D/DRC Case

1121 Daly Street

DESIGN/DEVELOPMENT REVIEW COMMISSION
DESIGN REVIEW DISTRICT
CONSENT AGENDA
EVALUATION SHEET
Case # 1

NATURE OF REQUEST: Request Certificate of Design Approval for exterior change (porch enclosure)

Photos provided by applicant show front of house, oblique view, side of porch and rear of porch, which has the best evidence of the brick detailing that will be restored on the front

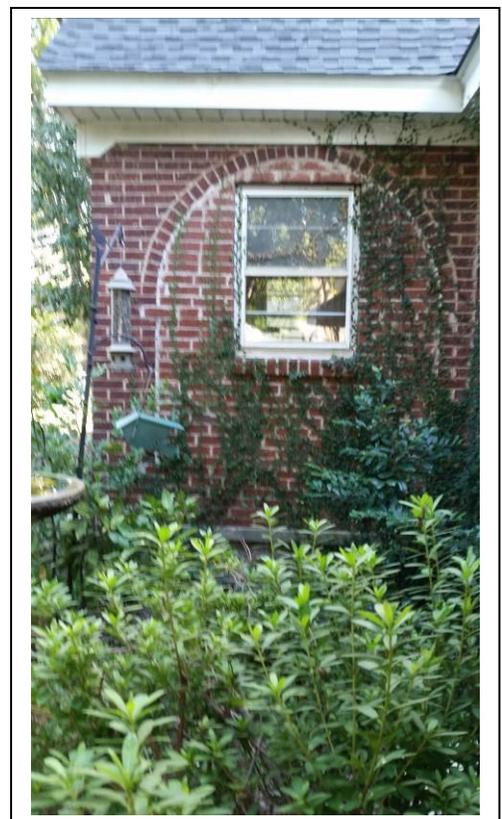
The front arch in the porch has been altered by the removal of the header course of bricks that delineated the arch; this detail is still evident on the back wall of the porch and will be recreated on the front, restoring a feature that was originally on the building.

Front and rear window dimensions

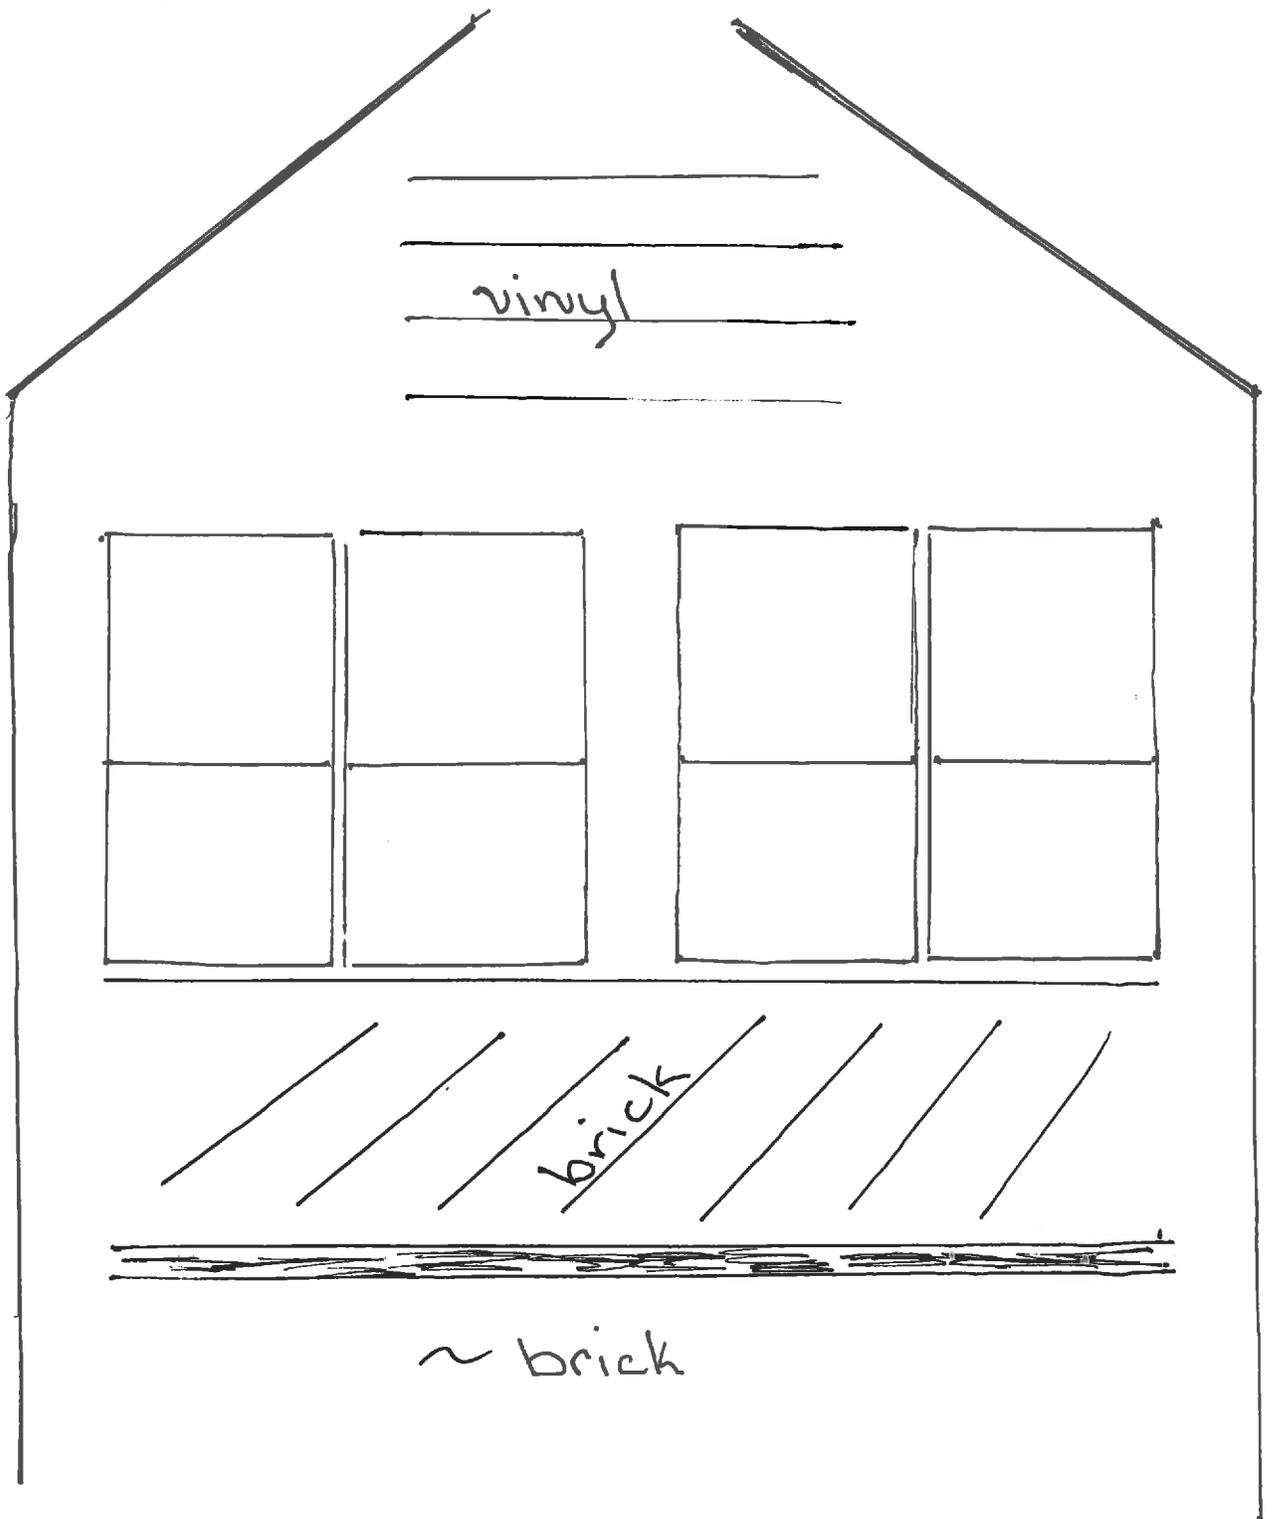
The replacement of most of the brick with glass in the openings of the side porch will meet this guideline as it will utilize a transparent material and will not obscure the original brick columns on the porch. The front of the porch has an arch and the glass needs to be cut to fill the entire “true radius,” which places the framing along the base of the arch, above two square windows. The side elevation, which is not highly visible, has a straight top with no arch; this will allow for two sets of 1/1 double hung sash windows, aluminum-clad wood, with a mullion between the pair. The remaining brick wall below these windows will match the height of the wall on the front of the porch, about 18 inches.
